Barbara J. Schussman
BSchussman@perkinscoie.com
D. +1.415.344.7168
F. +1.415.344.7368**VIA EMAIL**BDCP/WaterFix Comments
P.O. Box 1919, Sacramento, CA 95812
BDCPComments@icfi.com**Re: Partially Recirculated Draft Environmental Impact Report /
Supplemental Draft Environmental Impact Statement
(RDEIR/SDEIS) for the Bay Delta Conservation Plan/WaterFix**

Bay Delta Conservation Plan / California WaterFix
Partially Recirculated Draft Environmental Impact Report /
Supplemental Draft Environmental Impact Statement

Contra Costa Water District
Comments on the July 2015 RDEIR/SDEIS for the
Proposed Bay Delta Conservation Plan / California WaterFix

Figure 5-4. HORB affects water quality in the south and central Delta, sensitivity study results

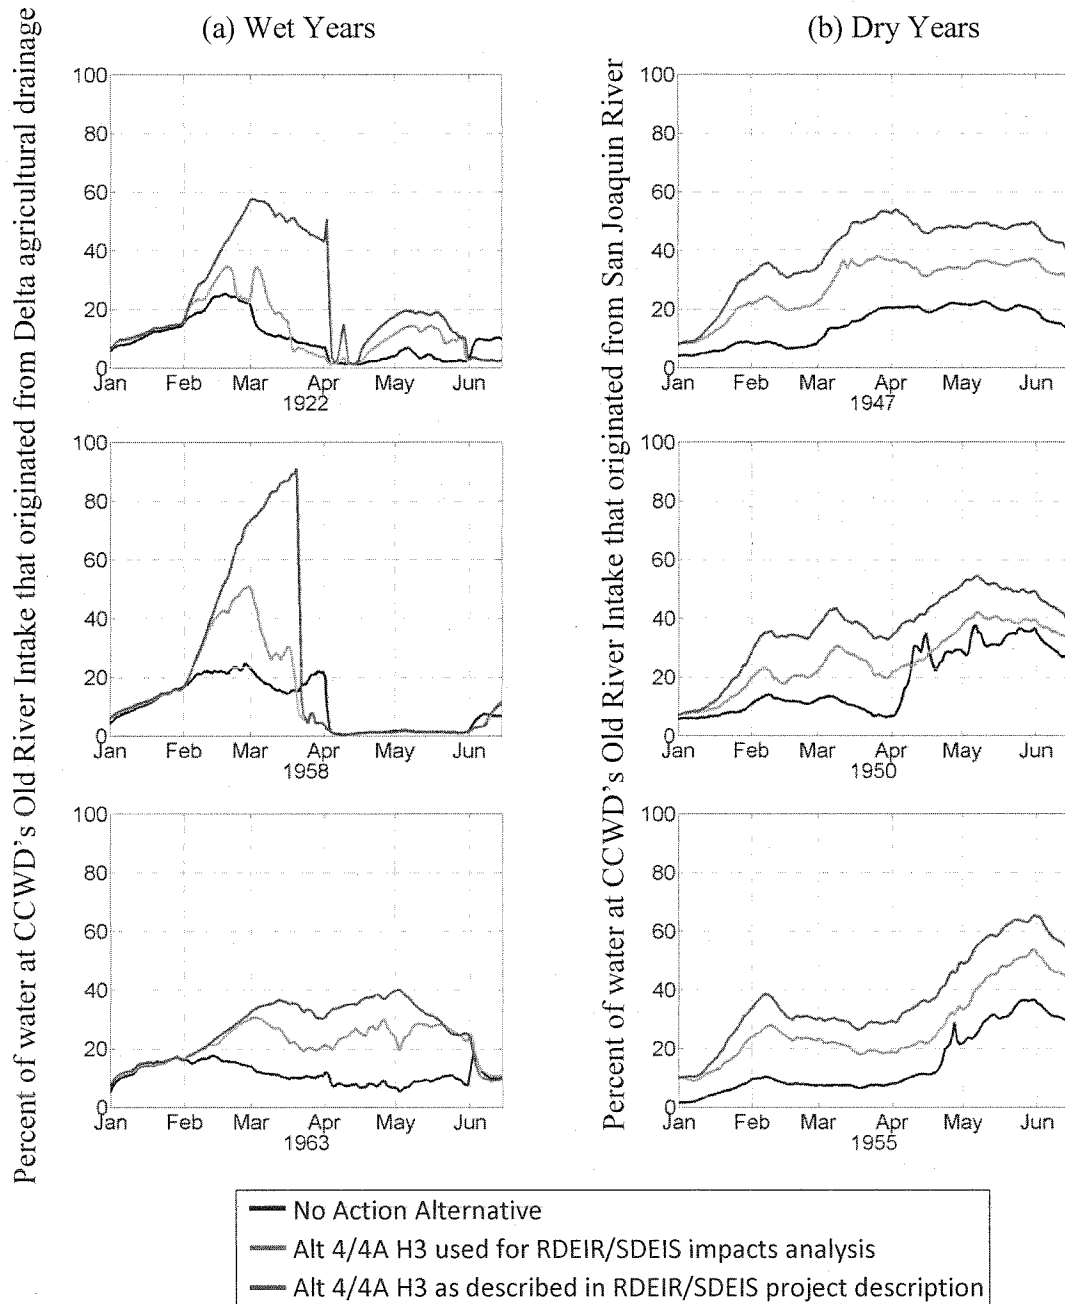
CCWD conducted a sensitivity study to evaluate the degree to which the analysis in the RDEIR/SDEIS underestimates the impacts of the new alternatives. Unlike the modeling used for the impact analysis in the RDEIR/SDEIS, CCWD's sensitivity study assumes that the HORB is closed when the project description indicates it should be closed. The CCWD study also reduced south Delta exports if necessary to attempt to meet the OMR requirement. Note that because no parameters are indicated in the project description to open the HORB for water quality or water stage concerns, this was not simulated in the CCWD study. Figure 5-4 illustrates the results for three wet years (Figure 5-4(a)) and three dry years (Figure 5-4(b)). In all six years, the negative water quality effects of the proposed project are greater than what is disclosed and evaluated in the RDEIR/SDEIS.

Results of CCWD's sensitivity study (red lines) indicate that the modeling used for the RDEIR/SDEIS impacts analysis (green lines) underestimate the project's adverse impacts on water quality relative to the baseline (black lines). In relatively wet years (a), an increase in percent of water from Delta agricultural drainage would increase salinity, nutrients, algal biomass, and pesticides at CCWD's intakes. In relatively dry years (b), an increase in the percent of water from the San Joaquin River would increase salinity, nutrients, and pesticides at CCWD's intakes.
